UNITED STATES PATENT AND TRADEMARK OFFICE

APPLICATION NO.	FILING DATE	FIRST NAMED INVENTOR	ATTORNEY DOCKET NO.	CONFIRMATION NO.
10/737,310	12/16/2003	Yoshitaka Mishima	121027-0202	5968

Office Action Summary	Application No.	Applicant(s)	
	10/737,310	MISHIMA, YOSHITAKA	
	Examiner	Art Unit	
	Michael G. Bogart	3761

DETAILED ACTION

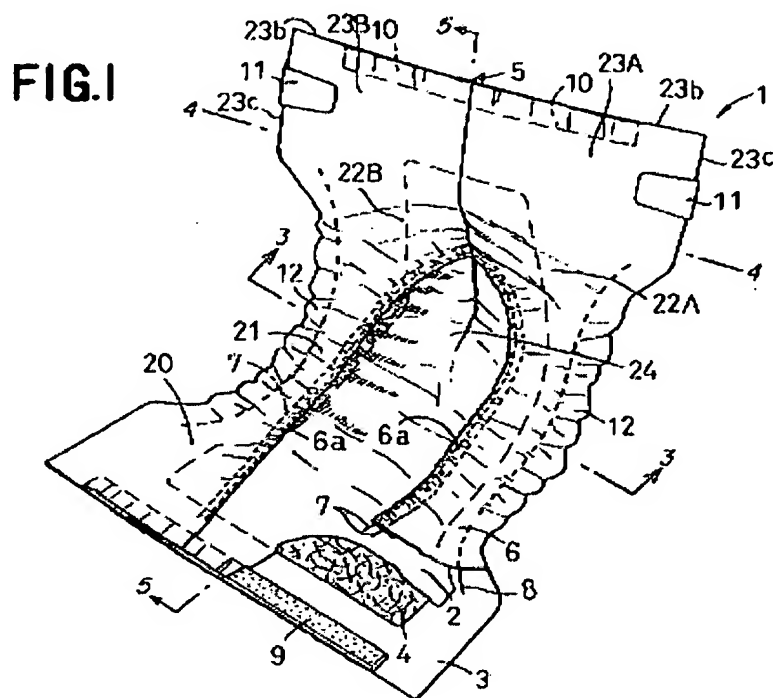
Regarding claim 1, Otusbo teaches a disposable undergarment (1) comprising:

a skin-contactable surface (2);

a non skin-contactable surface (outer surface of (3)) opposed to said skin-contactable surface (2);

a liquid-impervious base sheet (3) contoured by longitudinally opposite end portions (22) extending in a transverse direction and transversely opposite side edge portions (6a) extending in a longitudinal direction (Y);

a liquid-absorbent panel (4) attached to said base sheet (3); and

skin-contacting sheets (6) attached under tension in said longitudinal direction (Y) to said skin-contactable surface (2) of said undergarment (1) so as to cover said liquid-absorbent panel (4), said skin-contactable sheets (6) being stretchable in said longitudinal direction (Y) and substantially liquid-impervious, said skin-contactable sheets (6) having fixed surface areas (6c) secured to said longitudinally opposite end portions (22) and free surface areas extending (6a) between said fixed surface areas (6c), which free surface areas (6a) are not fixed to said undergarment (1) so as to be spaced upward from said liquid-absorbent panel (4) as said undergarment (1) curves in said longitudinal direction (Y) with its skin-contactable surface (2) inside, said skin-contactable sheets (6) are being made of a non-stretchable fibrous nonwoven fabric and elastically stretchable members (7) are being attached under tension in said longitudinal direction (Y) to said non-stretchable fibrous fabric so that said skin-contactable sheets (6) may have a stretchability in said longitudinal direction (Y)(figure 1).

Regarding the limitation concerning the non-stretchability of the fabric used in the skin-contactable sheets (6), the stretchable members (7) are added to the fabric to make the sheet (6) stretchable.

Regarding claim 6 Otusbo teaches that said skin-contactable sheets (6) comprise a pair of belt-shaped strips spaced apart from and opposed to each other in said transverse direction and respectively extending along said transversely opposite side edge portions of said undergarment

(1) in said longitudinal direction so that the skin-contactable surface (2) inclusive of said liquid-absorbent panel (4) is partially exposed between the skin-contactable sheets (6).
